**Bulletin #8 of 2022. June 20, 2022**

## **CHANGE TO PRODUCT BULLETIN**

### **P/N 540-095 Packing Washer Now 316L Stainless Steel**

*Current P/N 540-095 Packing Washer, left and center left, and previous, center right and right.*

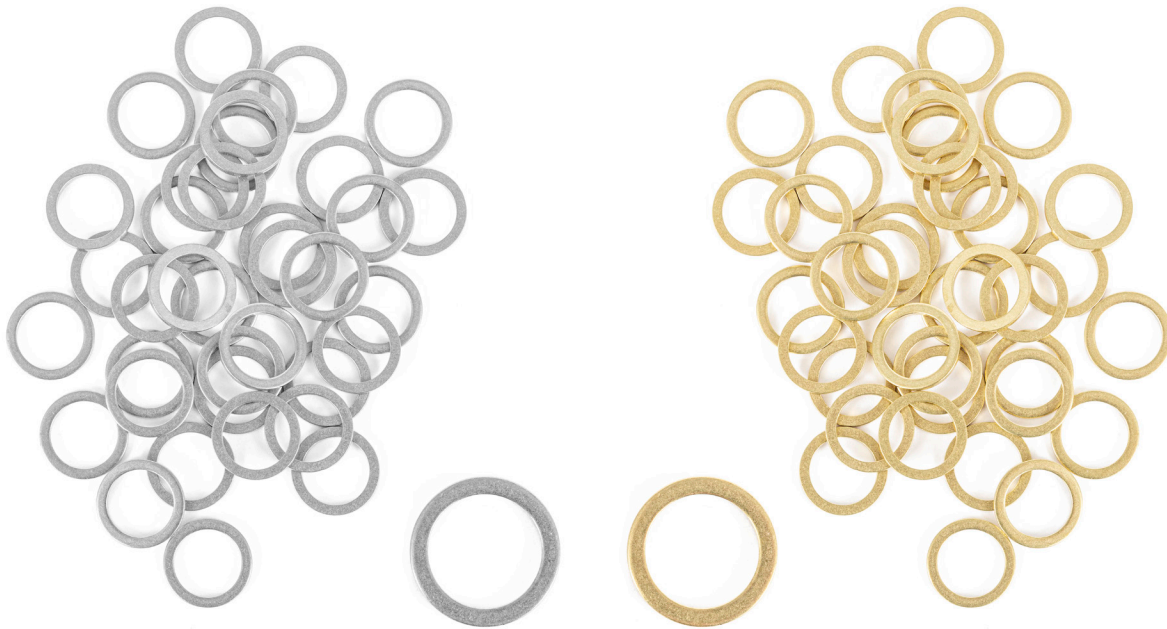
Switching from brass to stainless steel material will reduce the difference in the electrode potential between the Packing Washer and the Valve Stem adding to the longevity of the components.

Any old stock of the Packing Washer can be used without issue.

No change in part numbers.
